DDS- Planning & Zoning: Plan Review Application

Please describe your application action(s) and provide as much detail as possible. Attach additional pages if necessary: **special permit for outdoor drinking patio**

HOG RIVER BREWERY RELOCATION
 1420 Park St.
 Hartford, CT 06106

From: Paul Ashworth
Sent: Wednesday, July 13, 2022 3:34 PM
To: Berschet, Paige; Natalie Sweeney
Cc: Hartford Planning Division
Subject: RE: 1420 Park St - Special Permit Application - P&Z-COMM-2022-0264

① GROUND FLOOR USES AND SQUARE FOOTAGES

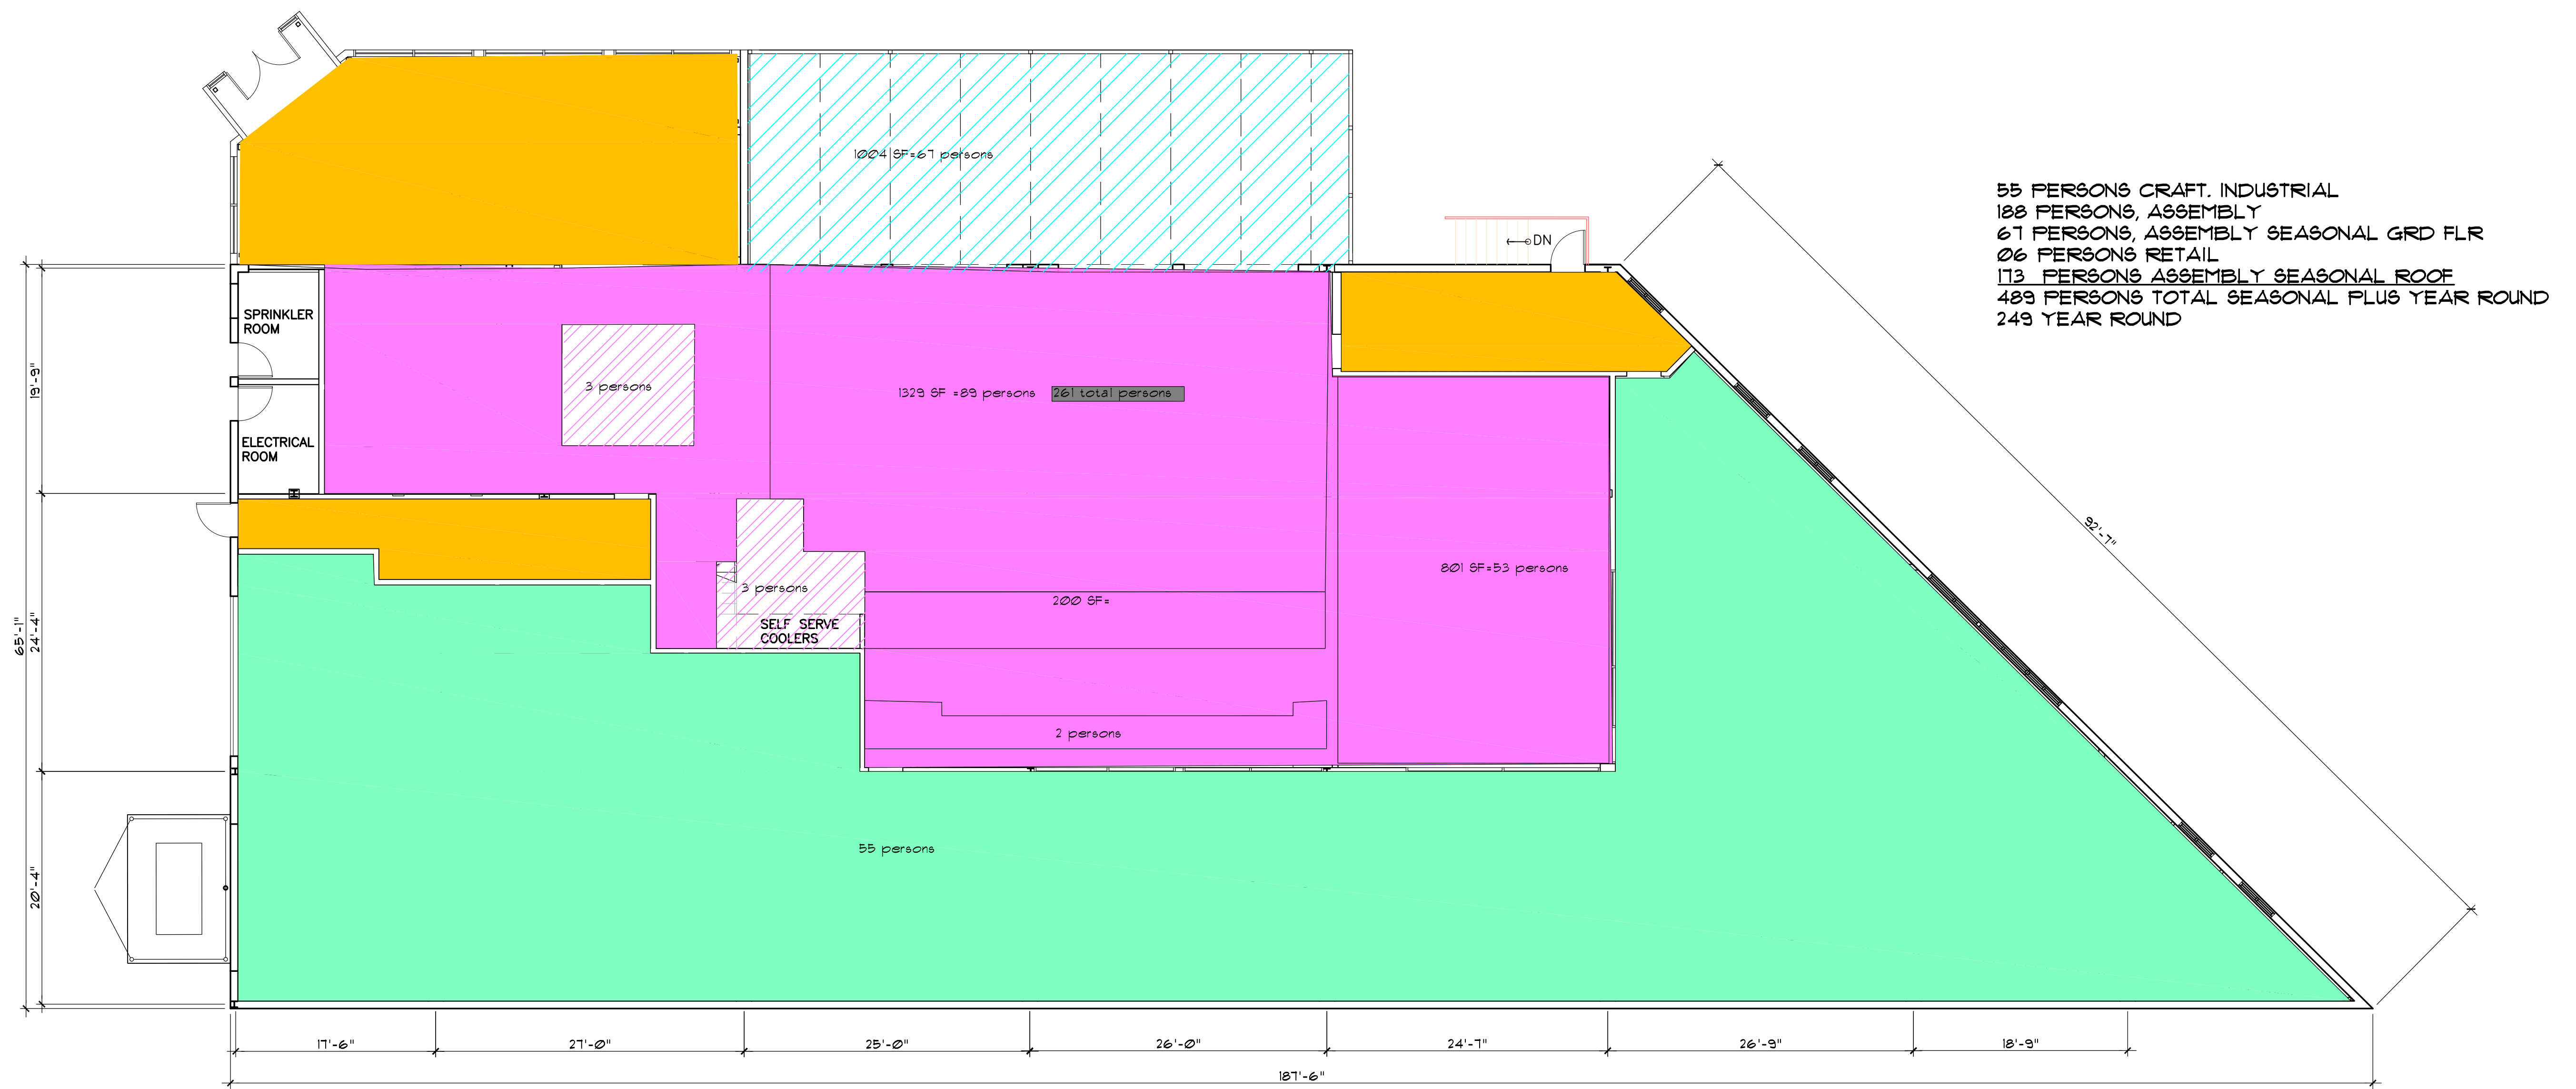
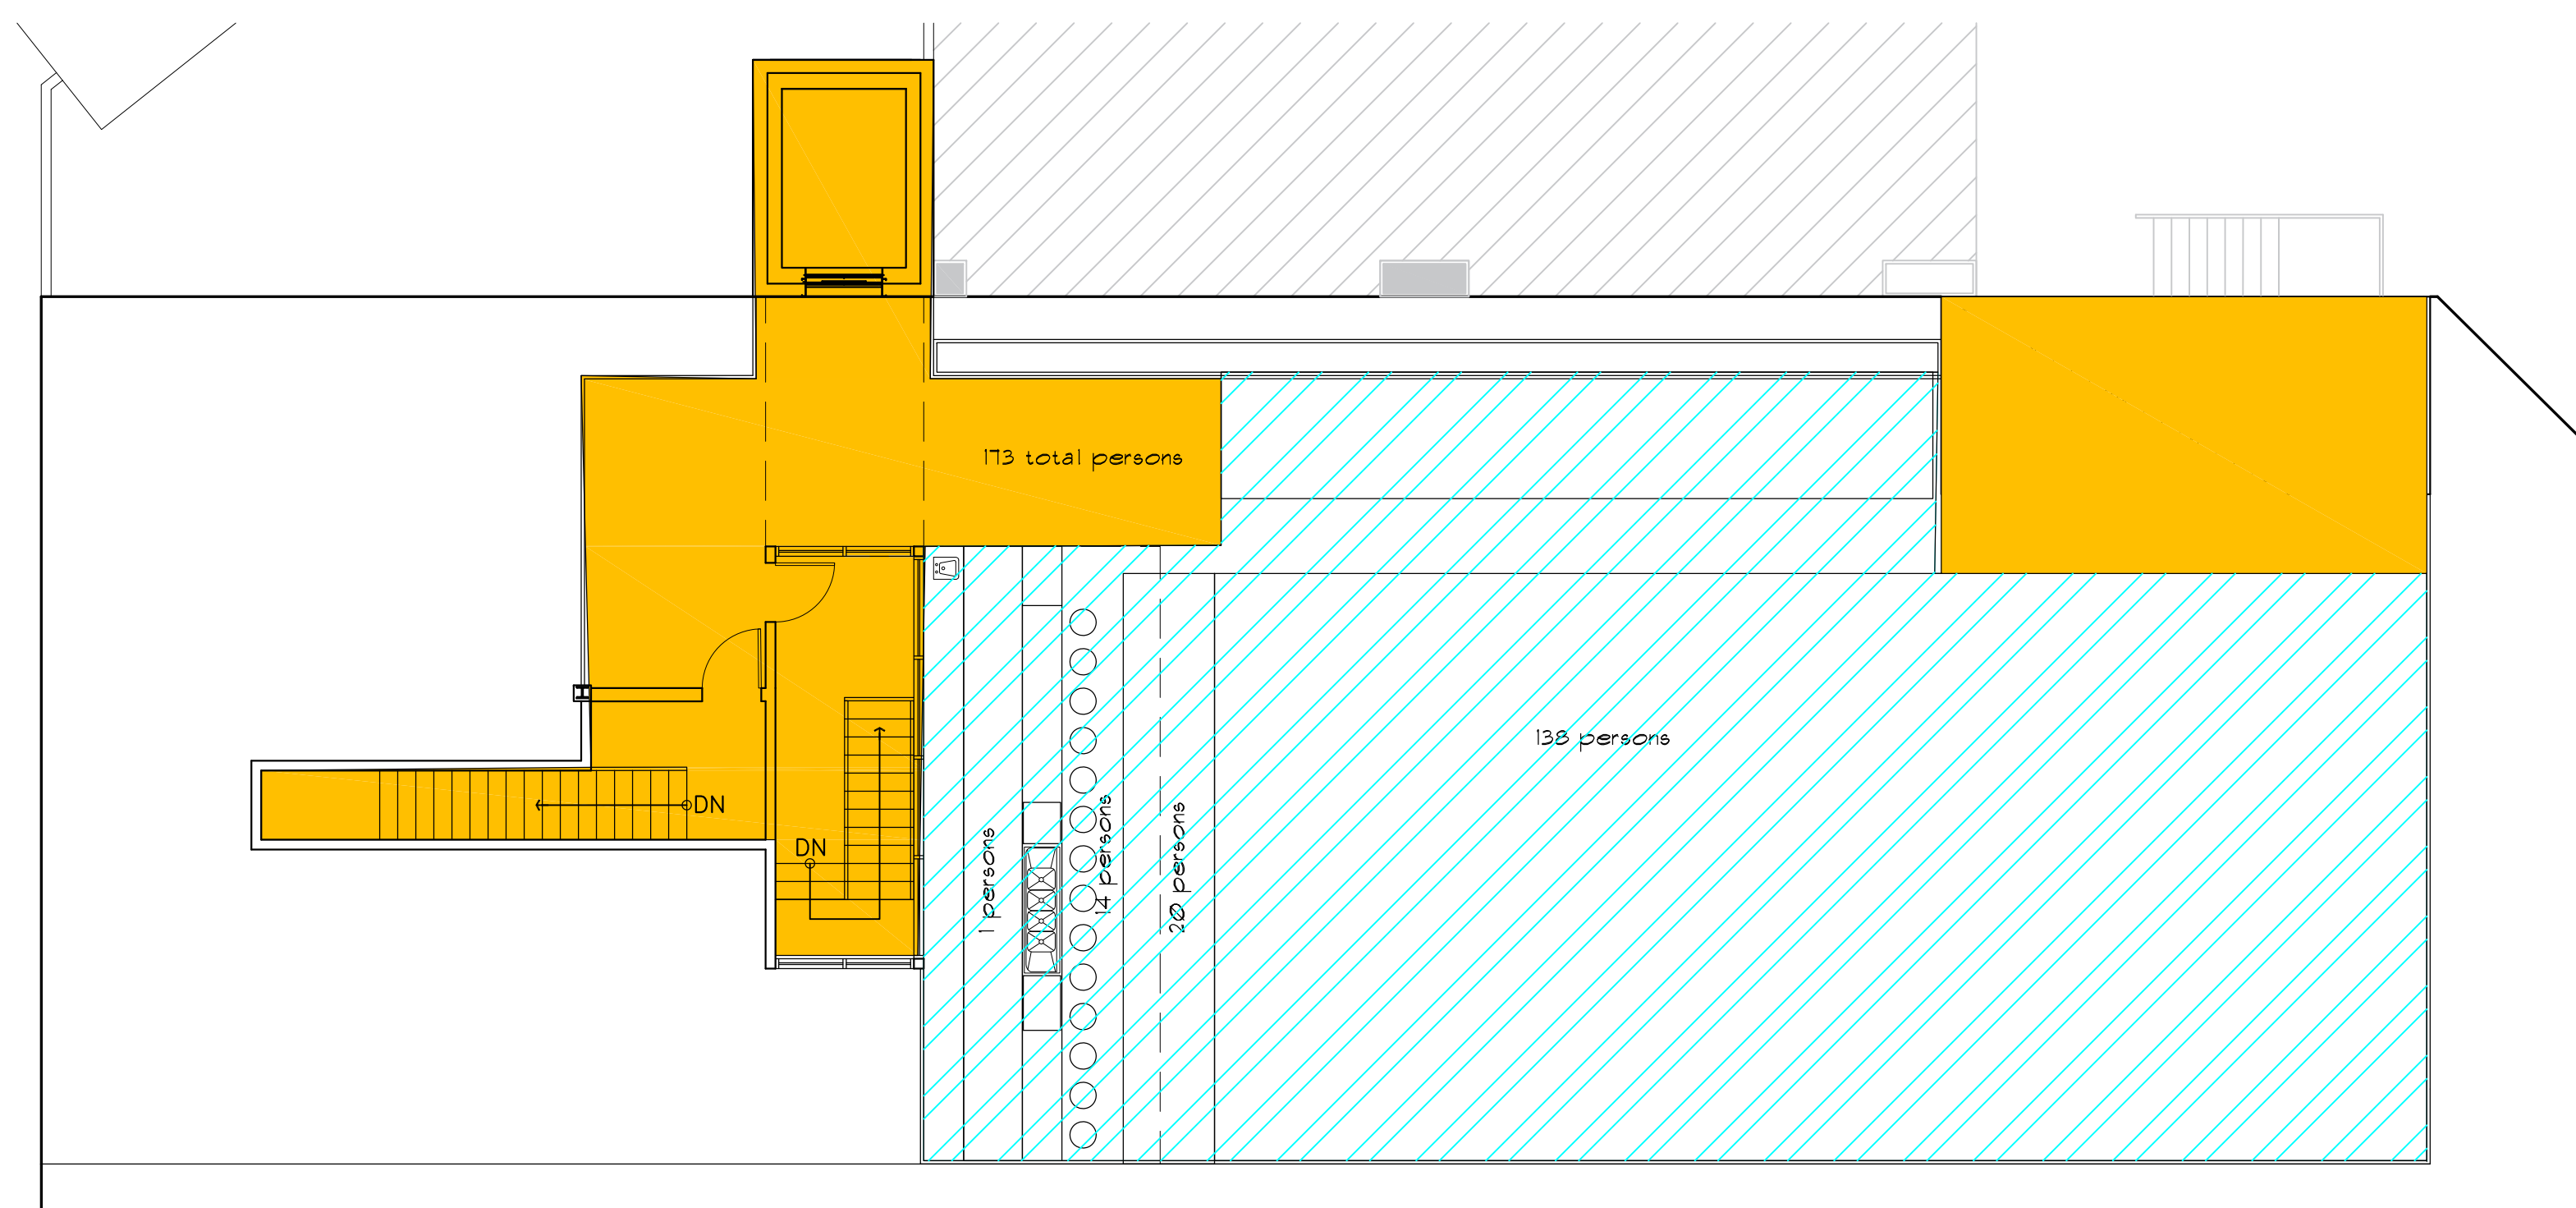
5. Please provide a square footage table. Please calculate the square footage of the overall use and the outdoor café. Include a calculation of the area devoted to Drinking or eating place. Sec.3.3.7.B requires that at least 10% of the square footage be used as a "showroom" or shop selling the product manufactured on site (drinking place).

5. Please provide a square footage table. Please calculate the square footage of the overall use and the outdoor café. Include a calculation of the area devoted to Drinking or eating place. Sec.3.3.7.B requires that at least 10% of the square footage be used as a “showroom” or shop selling the product manufactured on site (drinking place). **See use and square footage plan attached.**
